# MIAMI BEACH

### Staff Report & Recommendation

### Design Review Board

SUBJECT: DRB18-0251  
**959 West Avenue—TESLA charging stations**

Ground floor 959 West Avenue, permit plans B0103241

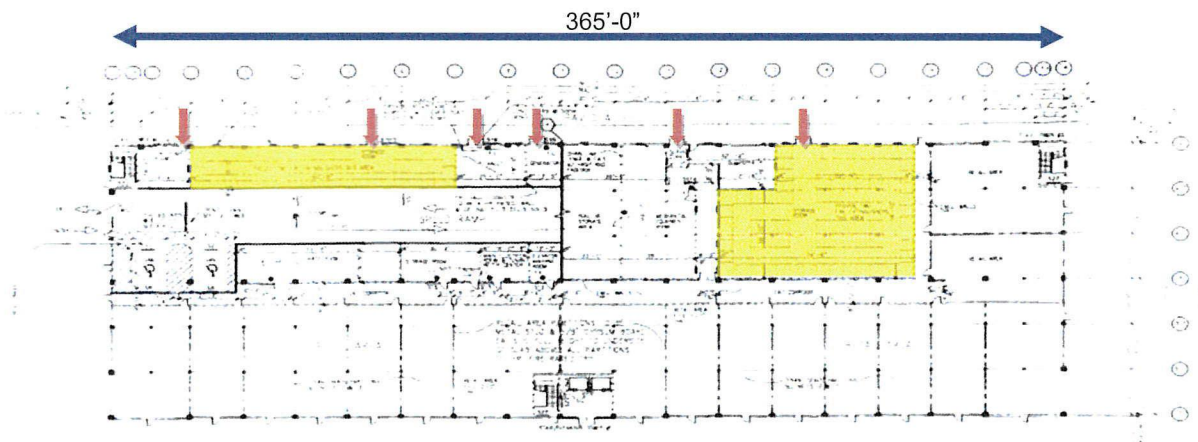
The existing building is constructed with approximately 365'-0" of linear feet abutting the alley. Along this extensive liner are two generous interior spaces, as highlighted below, which are identified as storage rooms, one measuring over 81'-0" in width and 18'-0" in depth and the other nearly a square measuring 74'-0" wide by 59'-0" deep. The applicant has an unusual amount of flexibility within the existing building to accommodate the electrical transformer within its shell without compromising interior spaces or parking stalls. As proposed, the electrical transformer and QED switchgear would be located in the limited sodded area along 10<sup>th</sup> Street that is barely 16'-0" wide. While the design does include landscape to buffer the transformer from the adjacent pedestrian sidewalk, the nearly 6'-0" cubed transformer and associated switchgear that is 7'-7" high will be difficult to conceal. Additionally, existing permeable area would be removed within a low lying area of the city.

Staff recommends that the utility transformer and QED switchgear be relocated into the shell of the ground floor of the garage. Permit plans indicate multiple access doors from areas of the garage identified as "storage", "FPL vault", "fire pump room" or "storage" onto direct access to the alley via the 8'-0" wide rear yard. Furthermore, the presence of the mechanical

equipment within the yards facing a street does not comply with the Design Review Criteria, as it is inconsistent with the established residential context.
